# Improving Positive Signal Headroom in eTap2hw

## eTap2hw

*A VINTAGE ECHO EMULATION*

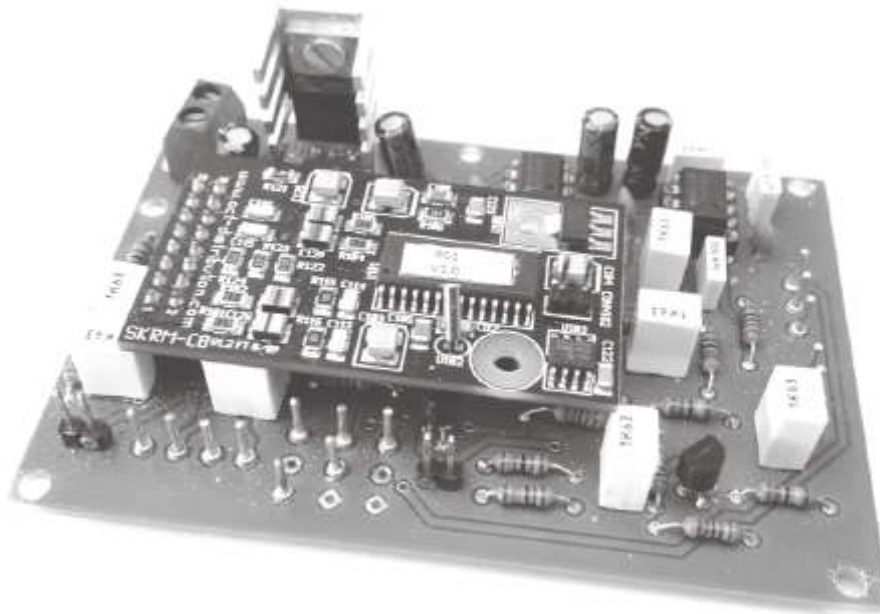
It has been brought to our attention that resistors R22 and R26 are unnecessary and put a DC offset voltage onto the input operational amplifiers' outputs. It is therefore recommended that these are simply clipped from the board. This will ensure that no clipping can occur during guitar transients as the 'positive voltage headroom' will be increased from less than 2V to greater than 4V.
